Docket Number:	06-AFC-07C
Project Title:	Humboldt Bay Generating Station - Compliance
TN #:	212312
Document Title:	Letter to CEC staff regarding Humboldt Bay Generating Station (06-AFC-07C)
Description:	Humboldt Bay Generating Station (06-AFC-07C), Minor Project Description Changes to Project Modification for Fiber Optic Communications System, Installation of a Microwave Dish and Monopole, and Re-Routing of an Existing Water Line Segment
Filer:	Cathy Hickman
Organization:	Chuck Holm, PG&E
Submitter Role:	Public
Submission Date:	7/15/2016 10:54:28 AM
Docketed Date:	7/15/2016

HBGS-CEC-129

SUBJECT: Humboldt Bay Generating Station (06-AFC-07C), Minor Project Description Changes to Project Modification for Fiber Optic Communications System, Installation of a Microwave Dish and Monopole, and Re-Routing of an Existing Water Line Segment

FIGURE 1
Proposed New Fiber Optic Line
PG&E Humboldt Bay Generating Station
Eureka, California

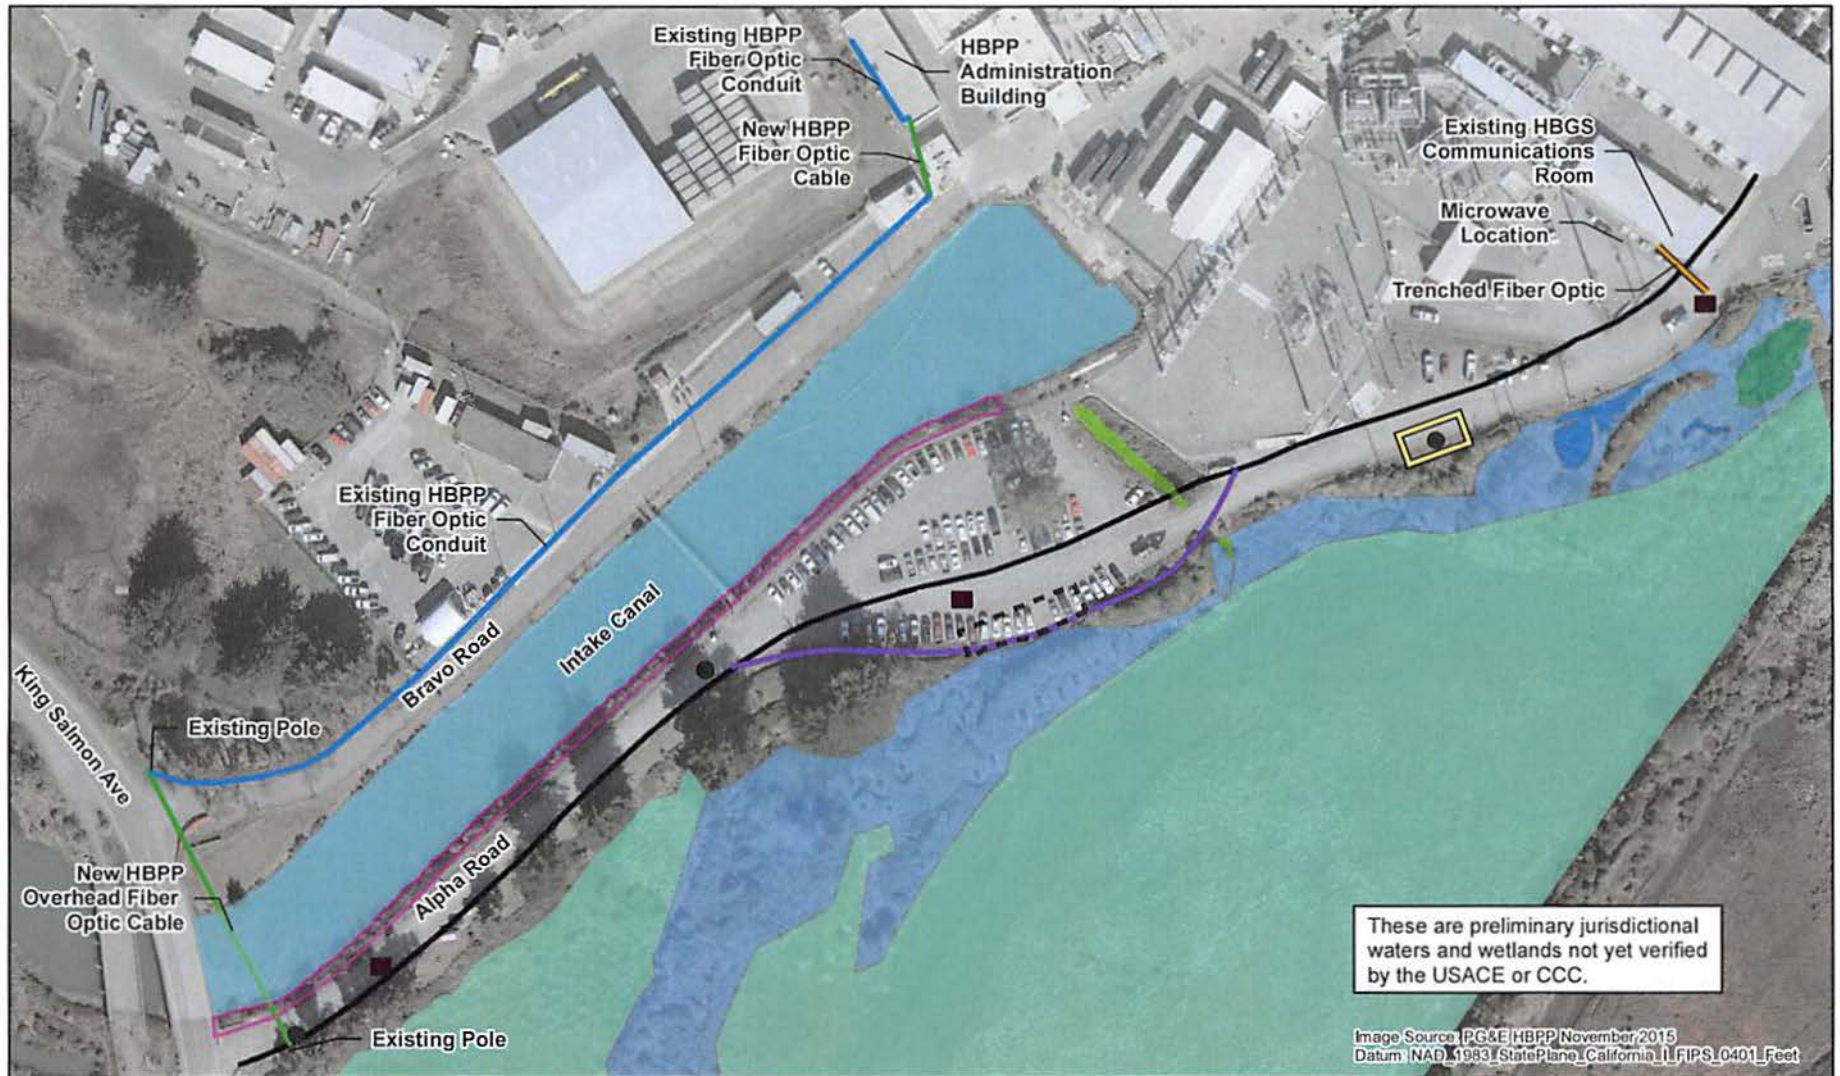
On May 5, 2016, PG&E submitted a Petition for Project Modification which included the installation of a fiber optic communications system. In the petition, PG&E stated that a 3 feet deep and 1-foot-wide trench would be excavated within a 26-foot wide corridor to install the two, four-inch fiber optic conduits (one conduit for the Humboldt Bay Generating Station (HBGS) and the other for the Humboldt Bay Power Plant (HBPP)) within which the fiber optic cables would be located. PG&E is now proposing a trenchless construction method, horizontal boring, to install the fiber optic conduits within Alpha Road, on the southeast shoulder.

The Petition for Project Modification also provided two location options for the pull boxes at each end of the fiber optic route. The specific location for these pull boxes has now been determined. In addition, a third pull box will be installed in the middle of the fiber optic route to aid in the installation of the fiber optic cable. The purpose of this letter is to describe these minor project description changes.

The horizontal boring construction method requires minimal excavation compared to conventional trenching. Specifically, it will involve excavating three bore pits within Alpha Road, on the southeast shoulder, as shown in Figure 1. The dimensions of the bore pits will be three feet wide by five feet long by 3 feet deep. The bore pits will be located approximately 200 feet to 500 feet apart from one another. A drill head attached to a two-inch steel rod will then be pushed through the soil between each bore pit, creating the pilot bore hole. A locating device on the drill head will direct the drill head to the adjacent bore pit. The conduits will then be attached to a back reamer which will be pulled through the hole, expanding its diameter to accommodate the conduits.

Once the conduits are installed, the pull boxes will be installed. The pull boxes are precast concrete vaults used in facilitating the installation of the fiber optic cables through the conduits. There will be three pull boxes installed along the southeast edge of Alpha Road, within the road surface (see Figure 1). One pull box will be installed at each end of the fiber optic route. Given the length of the route, a third pull box will be installed in the middle of the route.

The only trenching associated with the installation of the fiber optic cables and conduits, will be approximately 50 feet where the conduit and cables will cross Alpha Road and extend to the HBGS Communications Room (see Figure 1). The trench will be approximately 3 feet deep and 1 foot wide.
